Response to Reviewer Comments

WRF-MLGR v2.0 / EGU sphere Green-Roof Manuscript

Figure 1. Schematic comparison of the original and modified WRF multi-layer green-roof schemes.

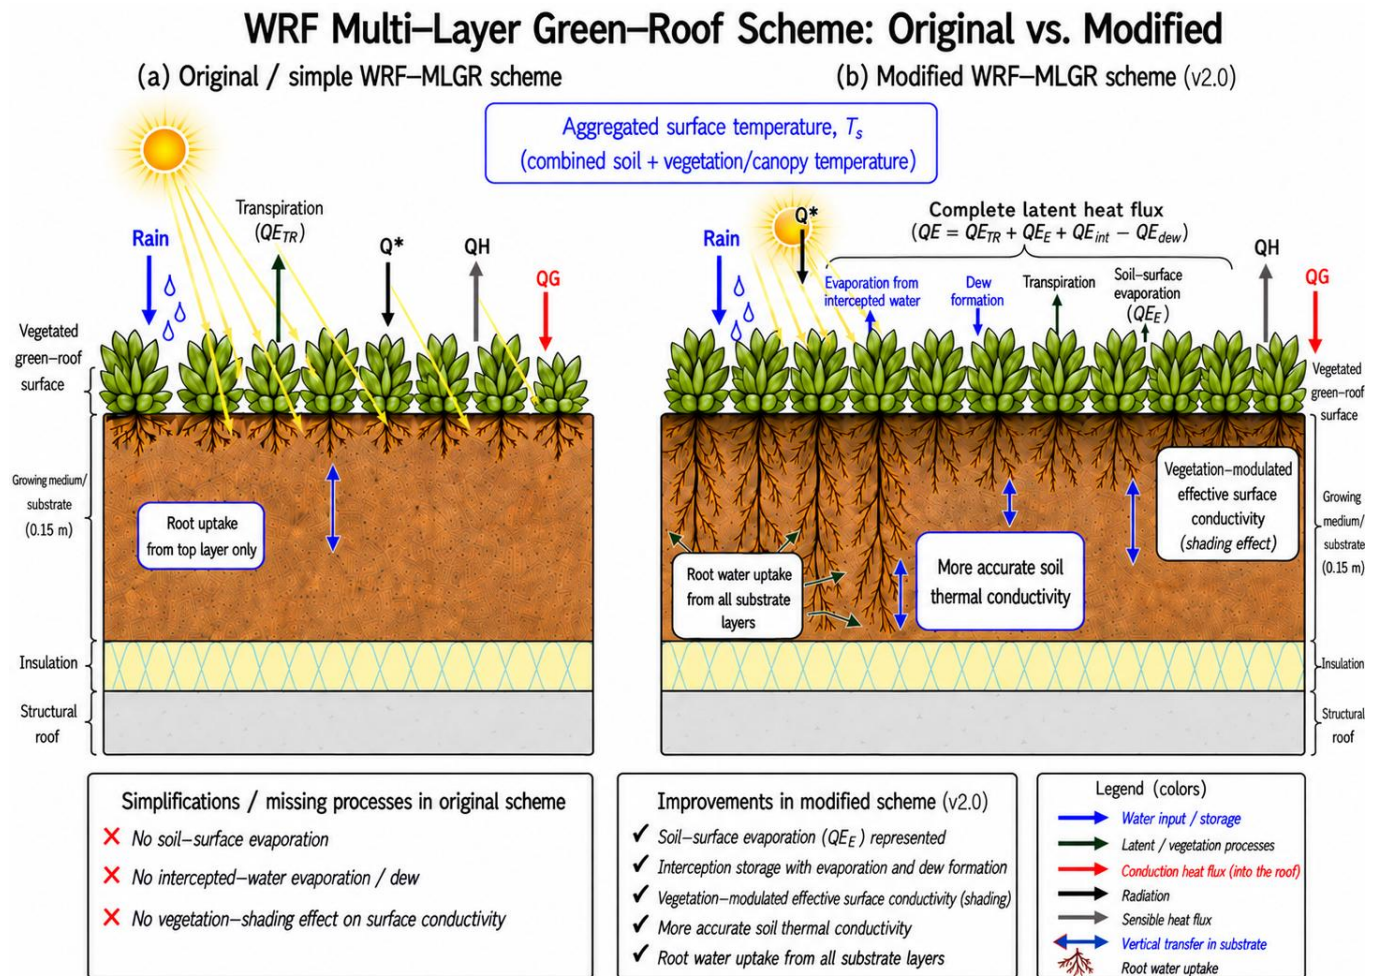
Reviewer comment: Section 2.2 describes the original model in text. Consider adding a schematic or flow diagram that contrasts the original scheme and the modified scheme to make the differences clearer (e.g., layer structure, heat flux pathways, and where parameter changes are applied).

Thank you for this helpful suggestion. We agree that a schematic comparison of the original and modified schemes improves the clarity of the model description. In response, we have added a new schematic diagram as Figure 1 in the revised manuscript. This figure contrasts the structure of the original model with that of the modified model and

highlights the main process-based changes introduced in this study. In particular, it illustrates the layer structure, the main heat and moisture flux pathways, and the locations where the parameter and process modifications were applied. We believe this addition makes the differences between the original and modified schemes much clearer for the reader.

We revised Sect. 2.2 of the manuscript, (page 6, lines 160–163), to clarify the structural and process-level differences between the original and modified WRF multi-layer green-roof schemes. Specifically, we added a new schematic as Fig. 1 and added explanatory text introducing the figure. The revised text now reads:

“To clarify the structural and process-level differences between the original and modified WRF multi-layer green-roof schemes, Fig. 1 provides a schematic comparison of the two model formulations. The figure highlights the main layer structure, the key heat and water flux pathways, and the locations of the five process-based modifications introduced in Sect. 2.3.”

Figure S1. Comparison of depth-averaged soil thermal conductivity between the original and modified WRF multi-layer green-roof schemes during summer 2014.

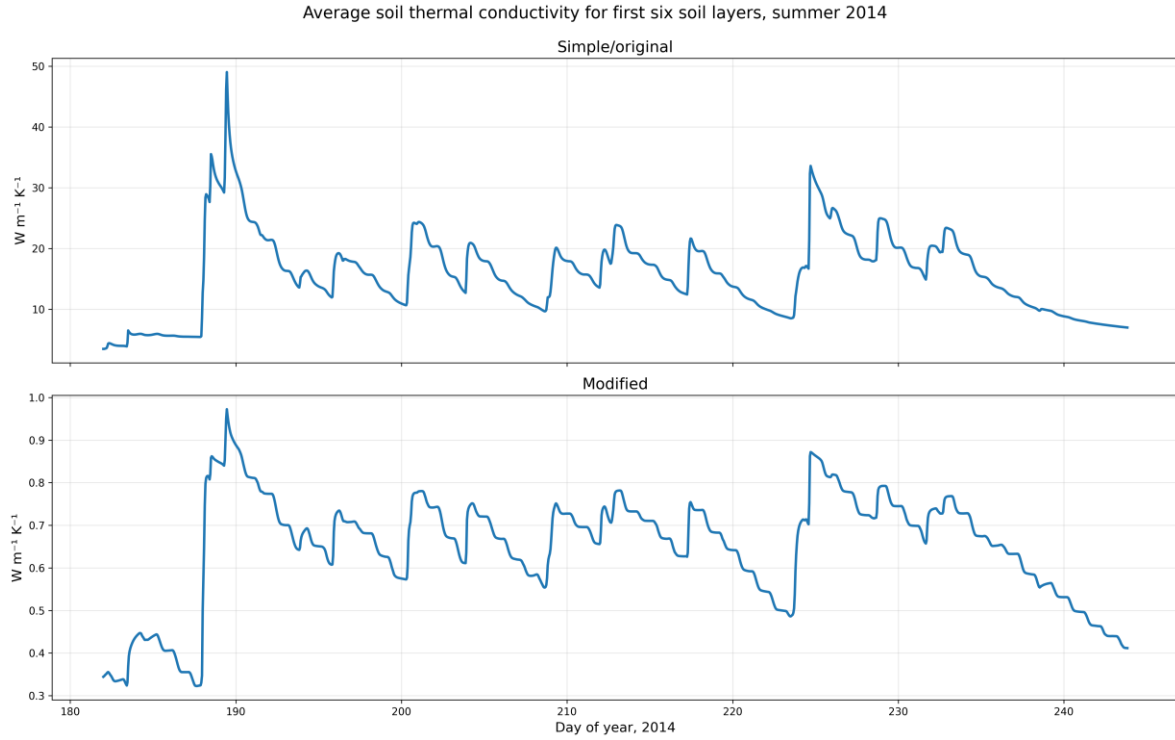
Reviewer comment: In Sections 2.3.1 and 2.3.2, please quantify how much the soil and vegetation thermal conductivities were changed relative to the original model. Are the modified values still within physically reasonable/observed ranges? If possible, include a table or figure showing the original vs. modified conductivity values and their sources or justification.

In response, we have added a new comparison figure as Fig. S1 in the Supplement. This figure compares the depth-averaged soil thermal conductivity simulated by the original and modified model configurations during summer 2014. Because thermal conductivity varies among substrate layers in the multilayer scheme, we calculated and presented the average thermal conductivity across the green-roof substrate layers for both the original and modified models. This allows a clearer comparison of the overall change in effective substrate thermal conductivity between the two model versions.

We revised Sect. 2.3.2 of the manuscript, (page 8, lines 215–221), to quantify the effect of the revised thermal treatment and to explain why the modified conductivity values are physically reasonable. We also added a new supplementary figure, Fig. S1, to show the depth-averaged soil thermal conductivity simulated by the original and modified schemes during summer 2014. The revised manuscript text now reads:

“To quantify the effect of the revised thermal treatment, we compared the time-varying average soil thermal conductivity produced by the original and modified green-roof schemes during summer 2014 (Fig. S1 in the Supplement). The original formulation produced unrealistically large and highly variable conductivity values, with peaks exceeding $49 \text{ W m}^{-1} \text{ K}^{-1}$, indicating excessive conductive heat transfer under wet conditions. In contrast, the modified formulation produced conductivity values mainly within the range 0.32 to $0.98 \text{ W m}^{-1} \text{ K}^{-1}$, which is physically more reasonable for engineered green-roof growing media, for which thermal conductivity has been shown to vary strongly with substrate moisture content and composition (Barozzi et al., 2017; Shao et al., 2021).”

The modified values remain within physically reasonable ranges reported for green-roof substrates and vegetation materials. We have also revised the text in Sections 2.3.1 and 2.3.2 to clarify the magnitude of the changes and to explain the physical basis for the modified parameter values. Because several additional diagnostic figures are already included in the Supplementary Material, we placed this comparison there rather than in the main manuscript.
